Car Stereo Service Sbletin

Model: CDX-45/45RF/51/65/65RF/
71; EXCD-1RF

No. 358R2

Subject: Skipping When Outer Tracks Are Played.

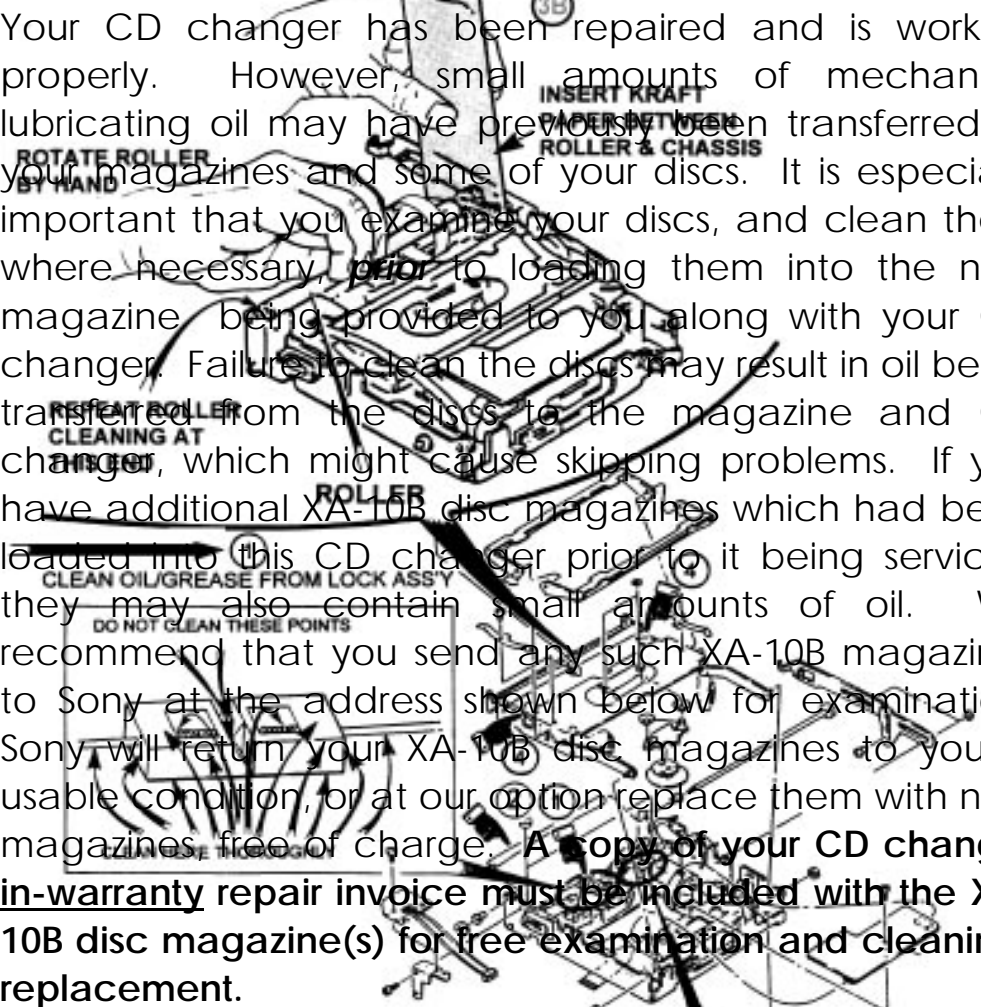
1- Thoroughly clean the grease and/or oil from the lock assy. **exactly as shown in the drawing.** First, remove any excess grease or oil by wiping the lock assy. with a dry cotton swab. Then, perform a final cleaning by wiping with a cotton swab moistened with alcohol.

2- Clean the rubber roller thoroughly with a cotton swab moistened with alcohol.

3- Move one side of the white plastic roller away from the metal plate, then thoroughly clean the roller (including the outer edge of the roller) with a cotton swab. Next, slip a piece of kraft paper (the paper that grocery bags are made of) between the ends of the roller and the chassis and rotating the roller by hand. Perform a final cleaning by wiping the roller with a cotton swab moistened with alcohol. Repeat this procedure for the opposite side of the roller.

4- Clean the white portions of the ARM(R) ASSY.

5- Remove the washer from the WORM WHEEL (C), then add a COVER (GEAR) and secure it with a +P 2x4 screw. Then reinstall the washer.
